CITY OF ALBUQUERQUE

Re: NMAC Building
1330 Cuesta Abajo
Traffic Circulation Layout
Engineer's/Architect's Stamp dated 1-20-16 (D16-D02F)

Based upon the information provided in your submittal received 2-5-16, the above referenced plan cannot be approved for Building Permit until the following comments are addressed:

TRAFFIC CIRCULATION LAYOUT

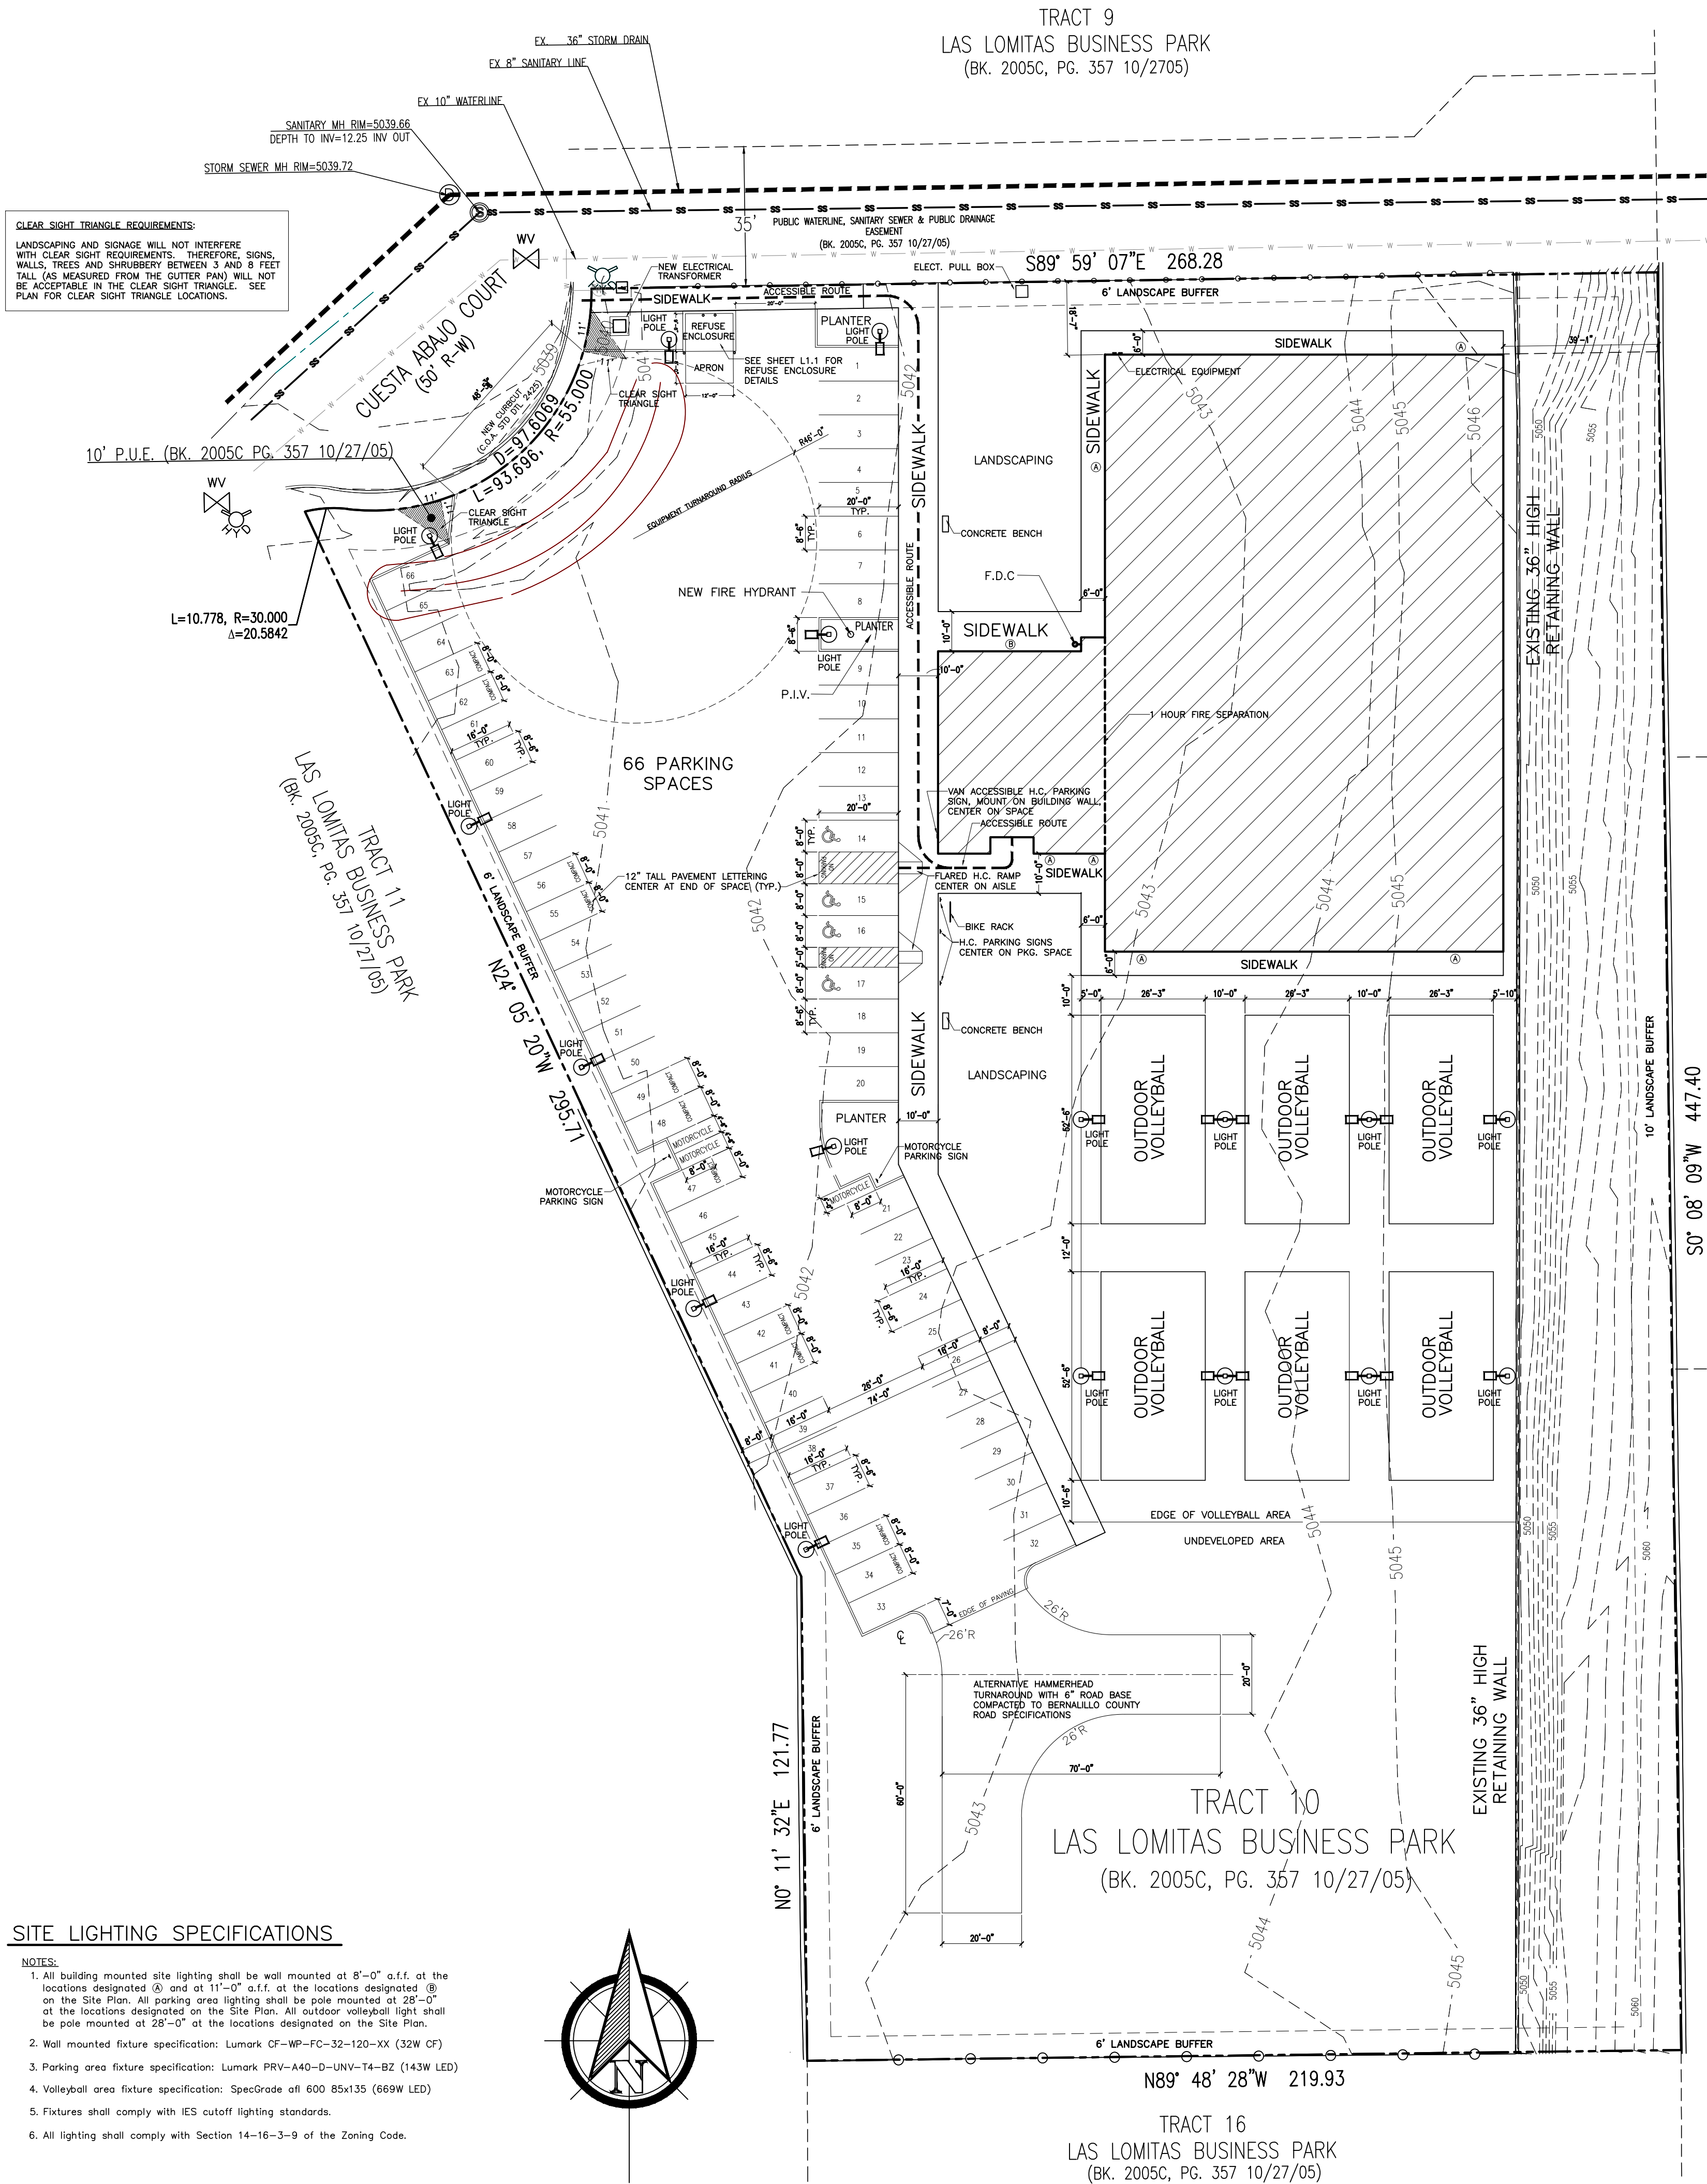
1. Please identify all existing sidewalks, curbs, drive pads on Cuesta Abajo Ct. and anything that influences the parking and circulation on the site.
2. Identify the right of way width, medians, curb cuts, and street widths on Cuesta Abajo Ct.

3. Please list the width and length for all parking spaces. Detail parking overhang into landscape and pedestrian walkways.
4. Label the compact parking spaces by placing the words **"COMPACT"** on the pavement of each space.

5. Parking is not permitted in front of the Fire Department Connection (FDC) and there shall be no obstructions within 15 ft. of a fire hydrant. The section of the site plan that calls out for a planter and the two adjacent parking spaces will need to be reconfigured, along with the parking calculations.

6. Per the DPM, a 6 ft. wide ADA accessible pedestrian pathway is required from the public sidewalk to the building entrances. Please clearly show this pathway and provide details of ADA approved ramps from Cuesta Abajo Ct.

7. All sidewalks along streets should be placed at the property line.
8. Provide a min 6" or max 8" high concrete barrier curb or other acceptable barrier between landscaping and parking areas and/or drive aisles. Please call out curb detail.

9. Design delivery vehicle route needs to be shown.
10. Service vehicle and/or refuse vehicle maneuvering must be contained on-site; provide a copy of refuse approval.

11. All broken or cracked sidewalk must be replaced with sidewalk and curb & gutter. A build note must be provided referring to the appropriate City Standard drawing.
